RE: Susitna-Watana Hydroelectric Project, FERC Project No. 14241-000; Comments on Request to Lift the ILP Abeyance and Approve Proposed Modifications to the ILP Plan and Schedule

Re: Susitna-Watana Hydroelectric Project, FERC Project No. 14241-000;
Support of the Alaska Energy Authority's proposed ILP schedule and request to lift the licensing
abeyance.

**SUSITNA RIVER COALITION’S RESPONSE TO THE NOTICE SOLICITING
COMMENTS ON REQUEST TO LIFT THE ILP ABEYANCE AND APPROVE
PROPOSED MODIFICATIONS TO THE ILP PLAN AND SCHEDULE**

Figure 1. Estimated Horowitz-Thompson (H-T) detection probabilities for brown bears in the Large Carnivore Study area (extracted from Figure 5.1-7 of the Large Carnivore ISR, page 26, red line and text box added).

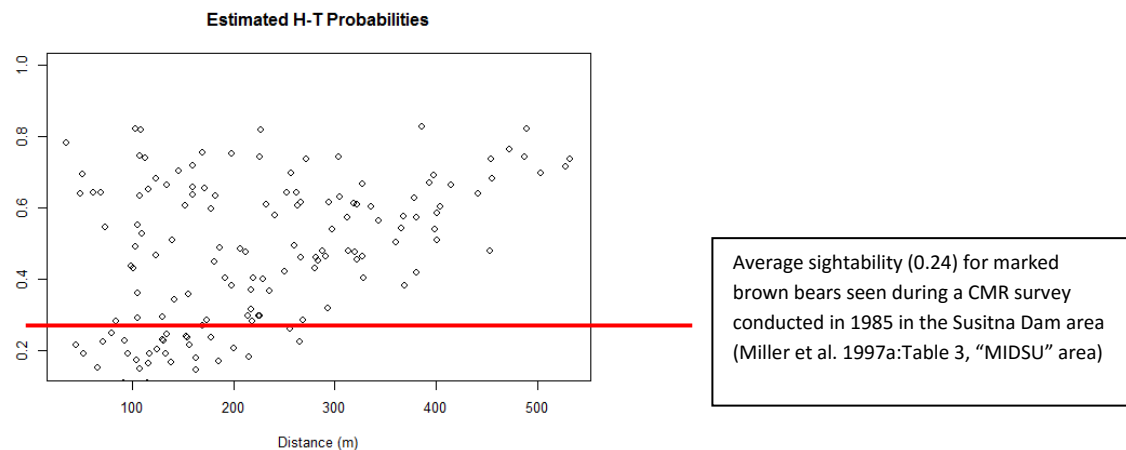
The calculated brown bear Horowitz-Thompson (H-T) detection probabilities for the MRDS surveys are shown in Figure 1. A red line displays the average sightability (24%) for a CMR study that was conducted in 1985 in the 1,317 km² study area used to estimate bear density (Miller 1987, sightability data in Miller et al. 1997a). Average sightabilities for many CMR studies in Alaska were presented by Miller (1997a:Table 3), and almost all of them are lower than the median detection probability for brown bears reported by AEA (0.485, ISR 10.8 Part A Page 8) (Figure 1). This comparison supports our suspicion that detection probabilities were overestimated in the MRDS technique reported by AEA (2014). This would have led to an underestimation of bear abundance.

E. Becker of ADF&G said that this comparison was invalid because detection probabilities for the MRDS technique were calculated differently than sightabilities for the CMR studies. Although calculated differently, for each of the detection probability points in Fig. 1, the likelihood that a particular bear would have been seen during a CMR survey flight would be higher. This is because of the higher search effort during CMR surveys. Additionally, the likelihood of any bear being seen in forested habitats that composed >50% of the Large Carnivore Study Area would be even lower than in the predominantly shrub habitats where the 24% sightability value was obtained during earlier Susitna studies (Miller 1987). Bears in these forested habitats would not only have detection probabilities less than the median of 0.48 reported in the ISR and illustrated in Fig. 1, the likelihood of observing these bears would be much less than the 24% found in the shrubby habitats of the 1985 Susitna study area.
